V2500-A1/A5/D5 PROPULSION SYSTEMS SERVICE BULLETIN

This document transmits Revision 3 to Service Bulletin EV2500-72-0415 and Revision 3 to the Supplement

ENGINE – PROVIDE NEW FRONT AND REAR NUMBER 4 BEARING DUCTS WITH OIL DRAIN HOLES

Duct Assembly, Cooling Air, No. 4 Bearing Front
Figure 1 (Sheet 1)

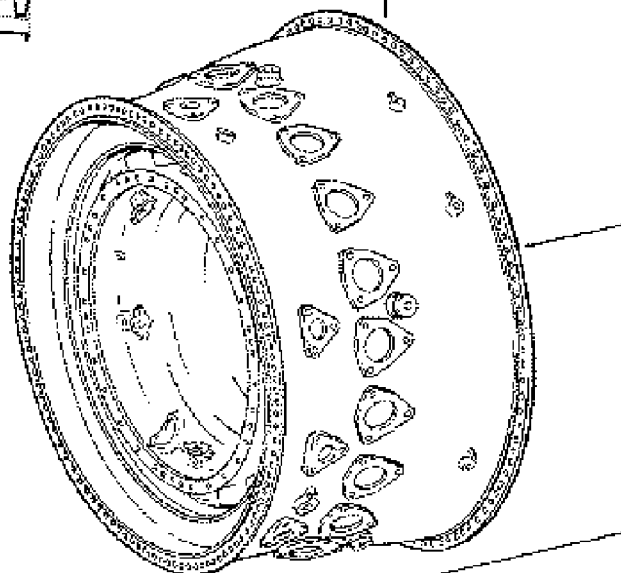
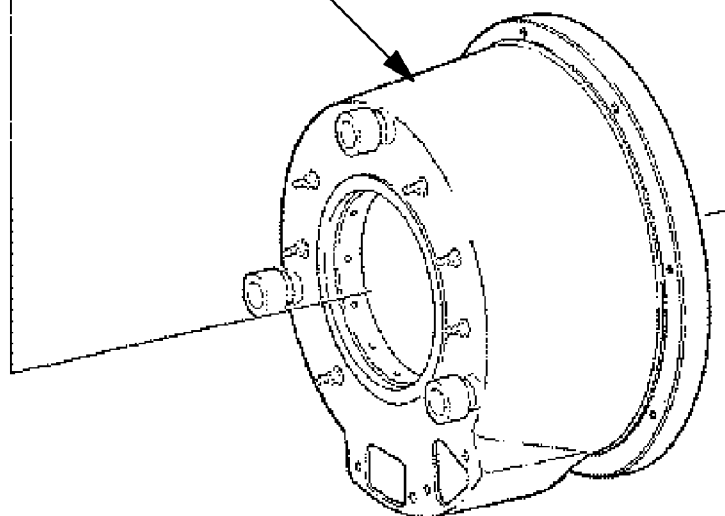
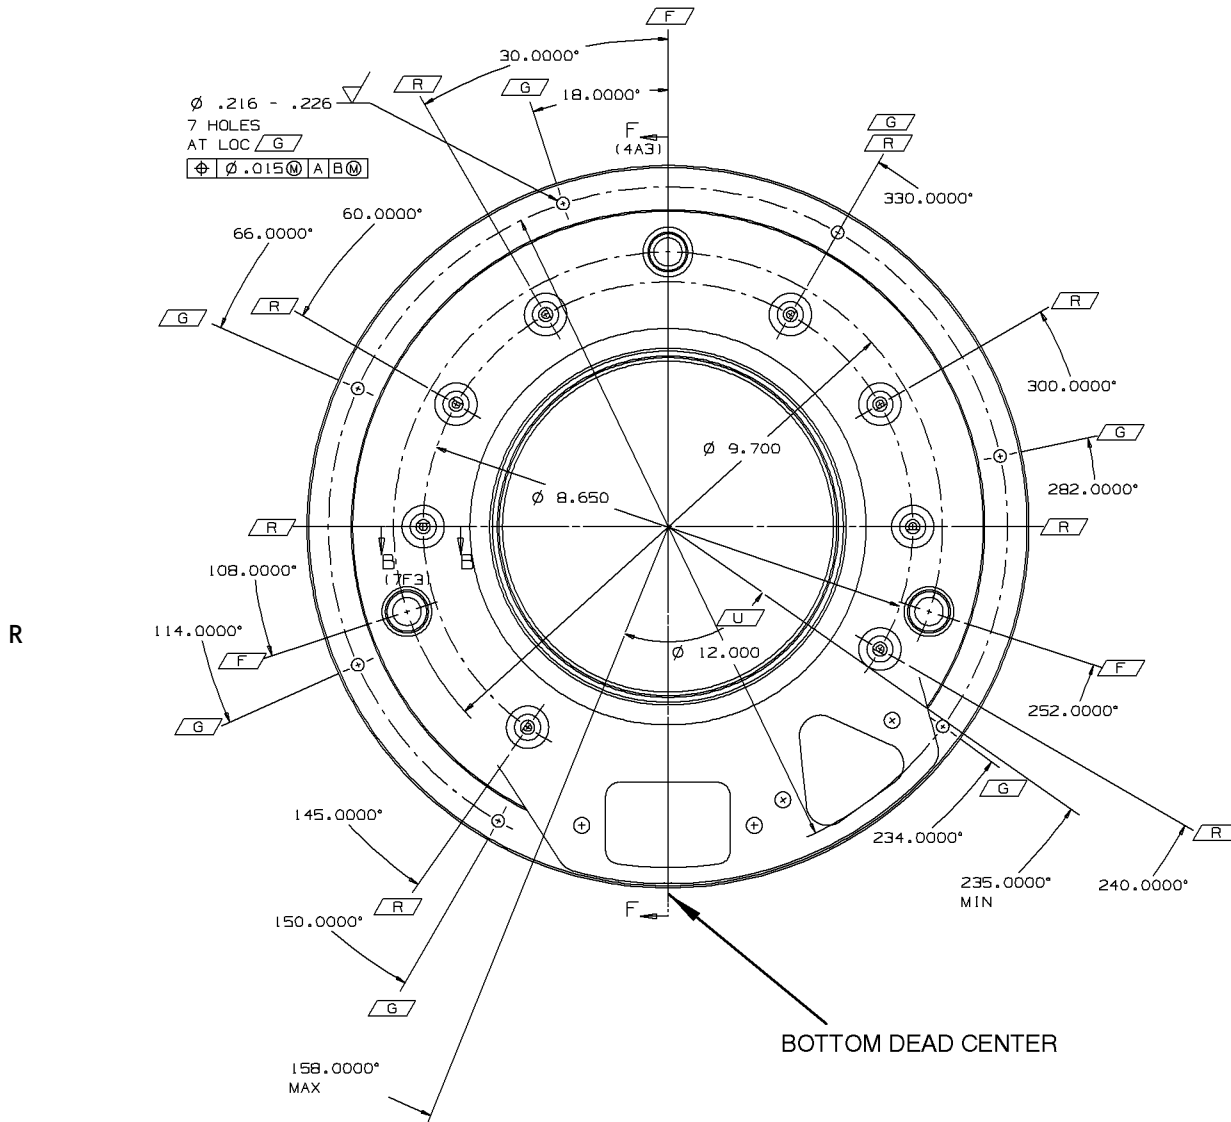
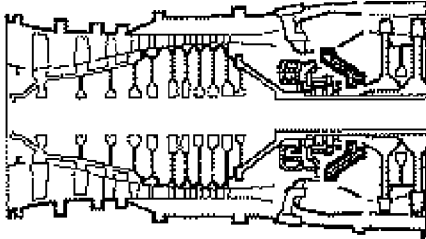
REPLACE DUCT 2A2257-01
OR 2A0892-01 WITH DUCT
2A3810-01 OR 2A0892-001
RESPECTIVELY

Duct Assembly, Cooling Air, No. 4 Bearing Rear
Figure 2 (Sheet 1)

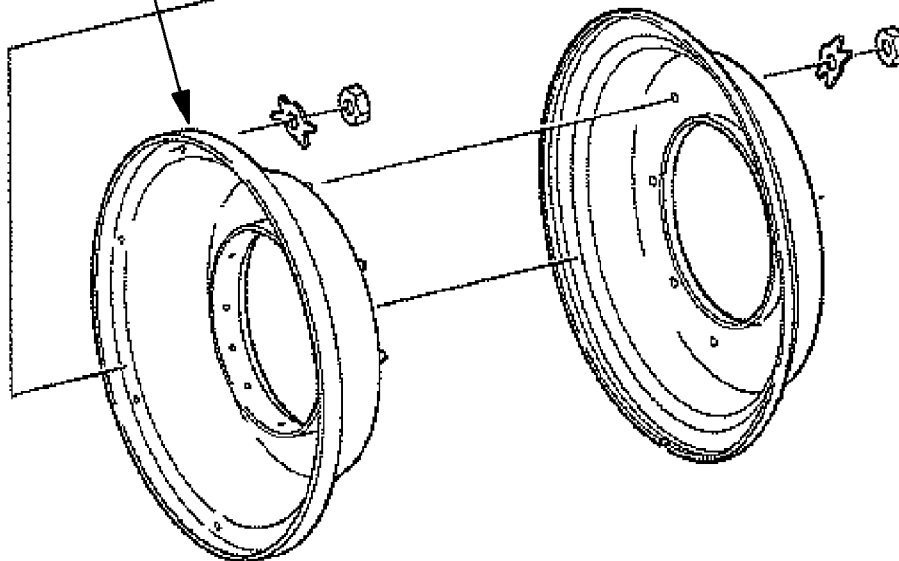
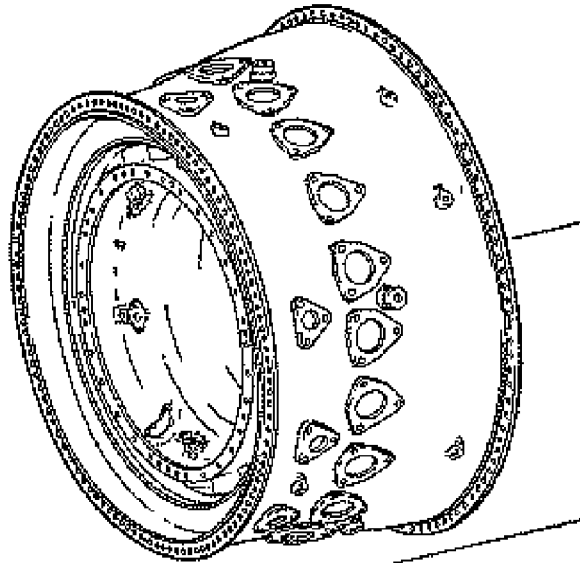
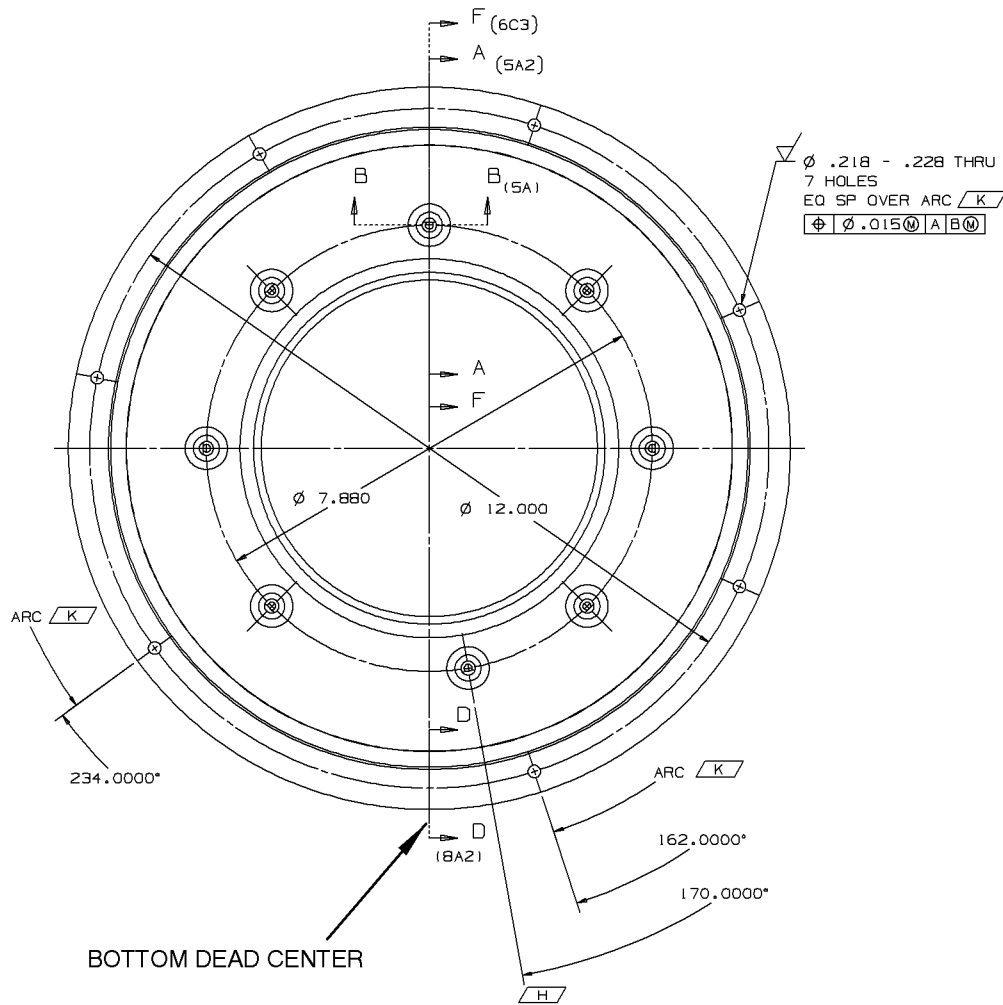
REPLACE DUCT 2A3078-01,
2A0891-01, OR 2A1205-01
WITH DUCT 2A3808-01,
2A0891-001, OR 2A1205-001
RESPECTIVELY

Front Duct Assembly, No. 4 Bearing Cooling Air
Figure 3

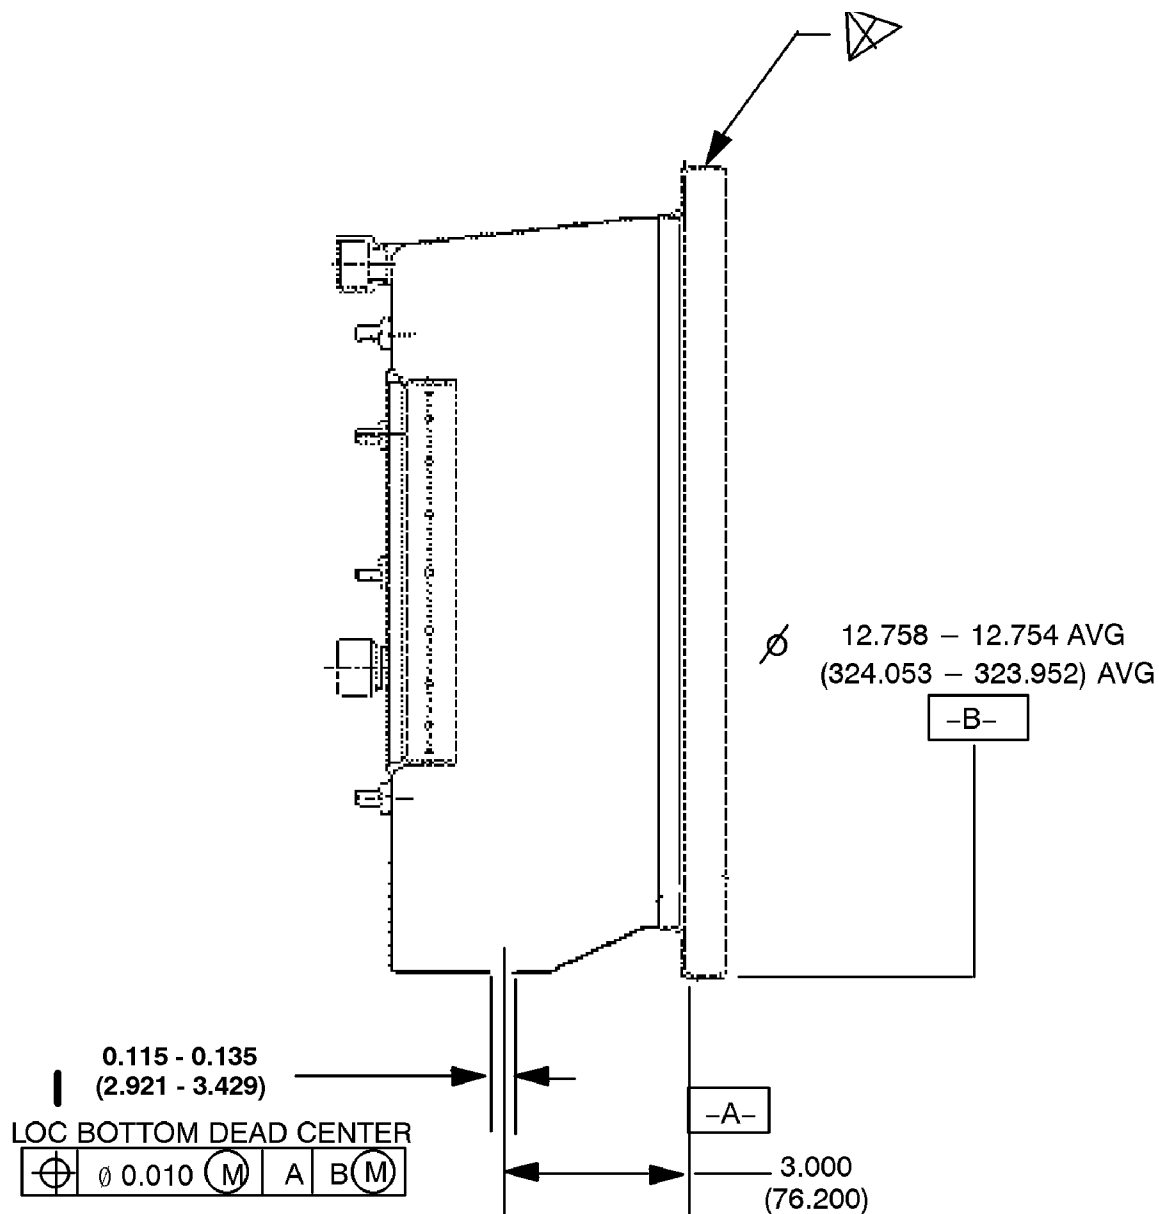
(ii) Produce a 0.115 - 0.135 in. (2.921 - 3.429 mm) diameter hole bottom dead center in the Number 4 Bearing Front Duct. See Figure 3.

(iii) Inspect per finished dimensions on Figure 3.

Rear Duct Assembly, No. 4 Bearing Cooling Air
Figure 4

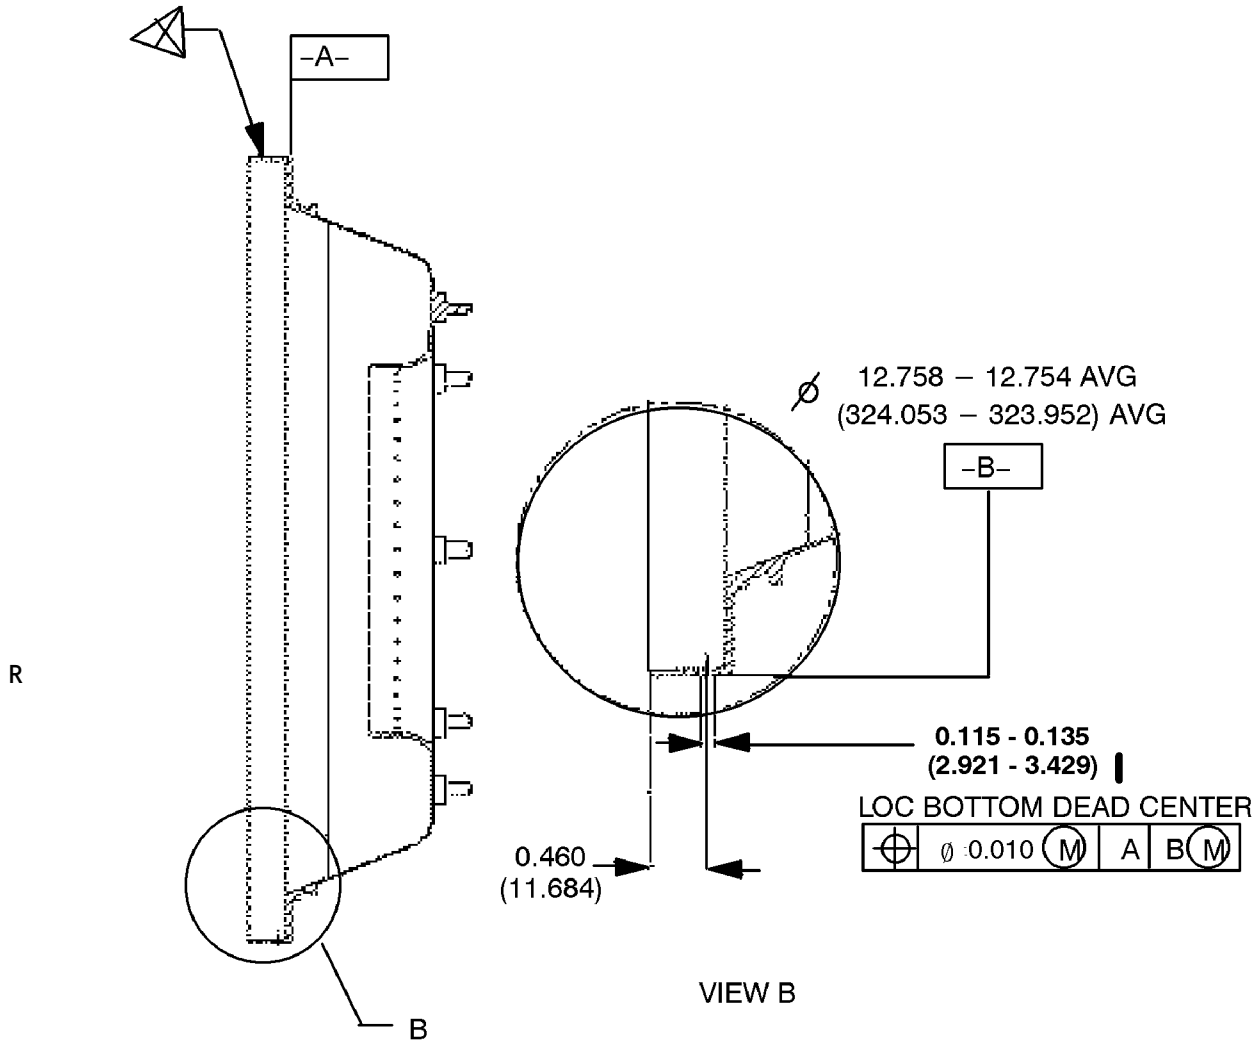
(ii) Produce a 0.115 - 0.135 in. (2.921 - 3.429 mm) diameter hole bottom dead center in the Number 4 Bearing Front Duct. See Figure 4.

(iii) Inspect per finished dimensions on Figure 4.
